SCHWEIZER SERVICE NOTICE

NOTICE NO. N-87.2*
DATE March 25, 1975
PAGE 1 OF 5

SUBJECT: INSTALLATION - PITCH CONTROL LINKS, LOW TIP
SPEED TAIL ROTOR ASSEMBLY (KIT NO. M10067)

MODELS AFFECTED: The following helicopters equipped with 269A6034
Low Tip Speed Tail Rotor Assembly:

Figure 1. Replacement - Tail Rotor (LTS) Pitch Link Assemblies (Kit No. M10067)

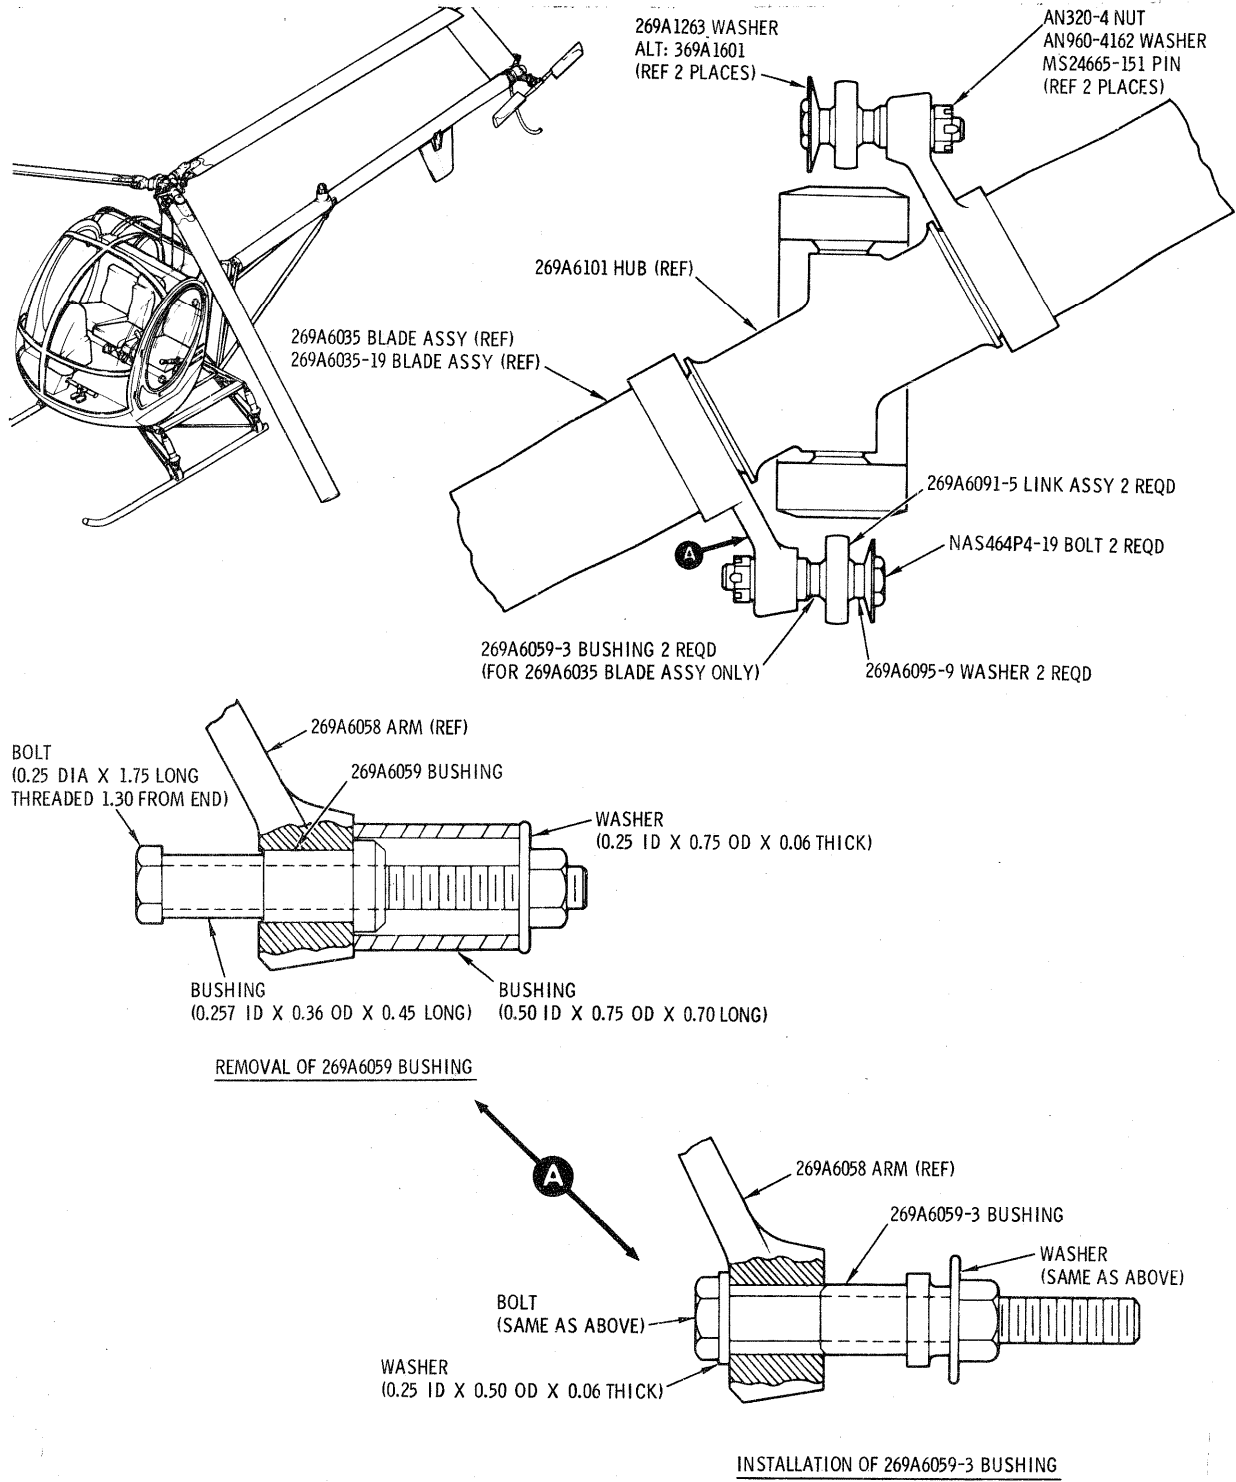
PREFACE: The information given in this Service Information Notice lists a
procedure for removal of existing 269A6091 tail rotor pitch control
links from the above affected helicopters and replacement with new
269A6091-5 pitch control links. The -5 link incorporates new type
bearings which provide additional link clearance at high pitch settings.
Instructions for replacement of bushings in the pitch control arms to
accommodate the new pitch link bearings are also included.

- c. Replace existing 269A6059 bushing in each pitch control arm as follows:
 1. Assemble bolt, bushings, washer and nut on pitch control arm, as shown in Figure 1; tighten bolt to remove 269A6059 bushing from arm.

2. Assemble bolt, washer, new 269A6059-3 bushing, washer and nut, as shown in Figure 1; tighten nut to seat bushing in arm. Install bushing with wet zinc chromate primer.

- e. Install existing bolt, two washers and nut; torque nut to 50 to 80 inch-pounds and install new cotter pin.
- f. Pull pitch control assembly inboard or outboard as required to align pitch control link bearing with pitch control arm bushing.

- g. Place existing spring tension washer on bolt so that concave (dished) surface is against bolt head; install new 269A6095-9 washer on bolt and insert bolt through bearing of pitch control link and bushing in pitch control arm.

- h. Install existing washer and nut.
- i. Torque nut to 50 to 80 inch-pounds and install new cotter pin.
- j. Repeat steps d. through i. for remaining link assembly.
- k. Reinstall tail rotor assembly, per Section 9 of Basic HMI. Replace existing bumper, if worn, with 369A1812-3 spacer and 369A1809 stop.
- l. Check installation of pitch link assemblies for discrepancies; check tail rotor controls for full travel and freedom of movement.
- m. Check tail rotor balance; adjust tail rotor balance, as required, per Section 9 of Basic HMI.
